**TOWN OF ACTON
HISTORIC DISTRICT COMMISSION**

CERTIFICATE 2524

CERTIFICATE OF APPROPRIATENESS

113 Main St

Above: Existing retaining wall

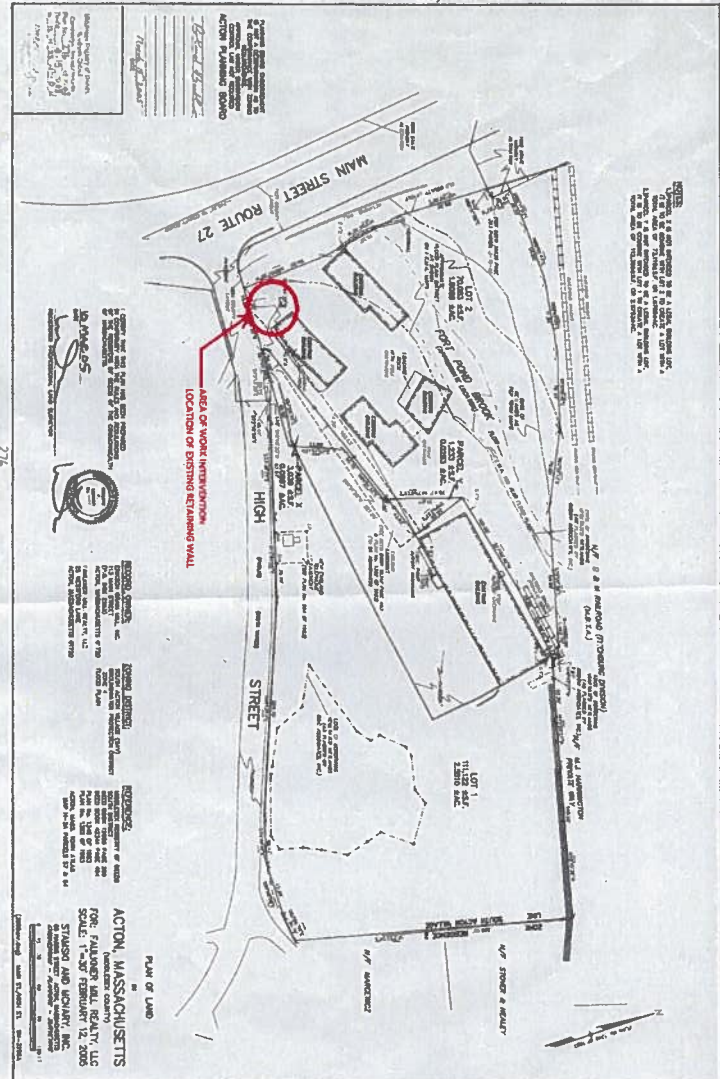
1. Wall of no historic significance and improperly constructed (not reinforced properly)

1. Material and construction shall be executed as outlined in Application 2524
2. Material is charcoal concrete trapezoid block with interlocking backing
